# CITY THEATRICAL I N C

## MODIFICATION PROCEDURE FOR *Source Four Fixtures* MANUFACTURED BEFORE JULY 1995

Figure 1

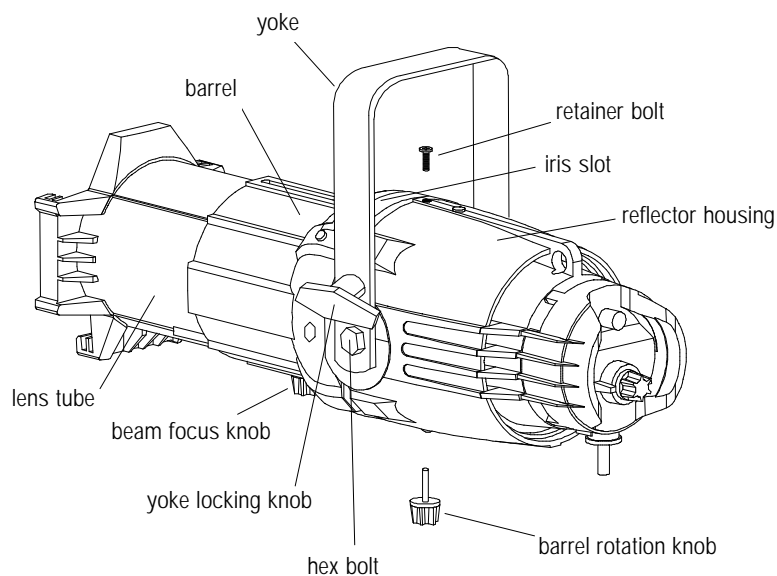
*\*Looking at the reflector housing -- the housing has three (3) holes in the casting --- one 1/4"-20 hole where the barrel rotation knob is screwed in and two 5/16" holes that secures the fixture to the yoke.*

- 3) On the side **opposite** the 1/4"-20 hole, make a 7/16" mark from the edge centered on the small ridge of that side.
- 4) Using a .201 drill bit, carefully bore a hole in the marked location.
- 5) Thread the hole with a 1/4"-20 tap.

*\*After the new hole has been drilled and tapped, the remaining work to be done is the same as with the new generation Source Four fixtures with the exception of using a 1" long flanged-head mounting screws instead of 1/2" flanged-head mounting screws. Proceed to Step # 3/c of Section 3-2 of the Autoyoke User Manual.*
